## URGENT FIELD SAFETY NOTICE ALL HOSPIRA PLUM™ A+ FAMILY OF INFUSERS CONTINUOUS REBOOT - UPDATE

Product name:	Plum A+ Family of Infusers
List Number:	11005, 11006, 11971, 11973, 12348, 12391, 12618, 20677, 20678, 20679, 20791, 20792
EMEA FA ID:	EMEA.2011.010
Date:	21 September 2012

This letter is to provide you with an update on the status of the correction plan for the Plum A+ Reboot/Recycle Urgent Device Field Safety Notice issued by Hospira in October 2011.

Figure 1.

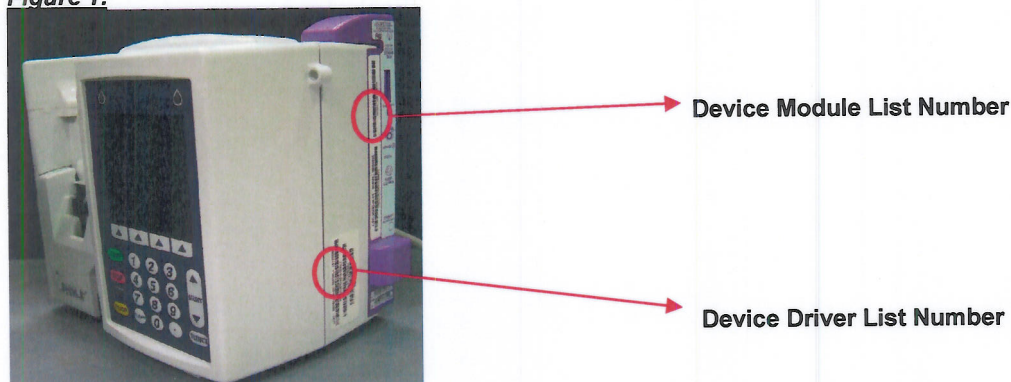
- The Plum A+ single channel pump comprises a device driver and device module. Device modules with v13.0, v13.1, v13.2, v13.3, v13.40, and v13.5 software will require the software upgrade.
- The location of the Device Drive list number and Device Module list number is shown in *Figure 1. Single channel Plum A+ Pump - Location of Device Module and Device Driver List Numbers.*

If you have the following Device Module list numbers, regardless of Device Driver list number, you will be receiving a software upgrade:

Device Module List Number	Requires Software Upgrade	EMEA Impacted
20679	Yes	X
20677	Yes	X
20791 + 20792	Yes	✓ Saudi Arabia Only
11006	Yes	X

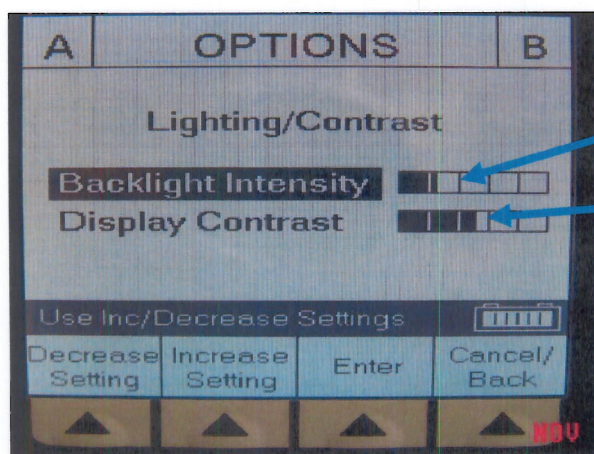
**Please continue to keep the display settings at the default condition, as described in the October 2011 letter and re-iterated again below, until the upgraded software is installed at your site.**

To prevent an occurrence of continuous recycling/rebooting during start-up, adjust the backlight intensity and contrast settings as described below:

1. Go to the Lighting/Contrast Screen under "Options"
2. Backlight Intensity: Set to one (1) increment past one (1) full bar from the left as shown in the picture below.
3. Display Contrast: Set to five (5) increments below three (3) full bars as shown in the picture below.
4. Press enter to save the settings. Correct LCD settings below:

**Backlight Intensity – One (1) increment above one (1) full bar.**

**Display Contrast – Five (5) increments below three (3) full bars.**
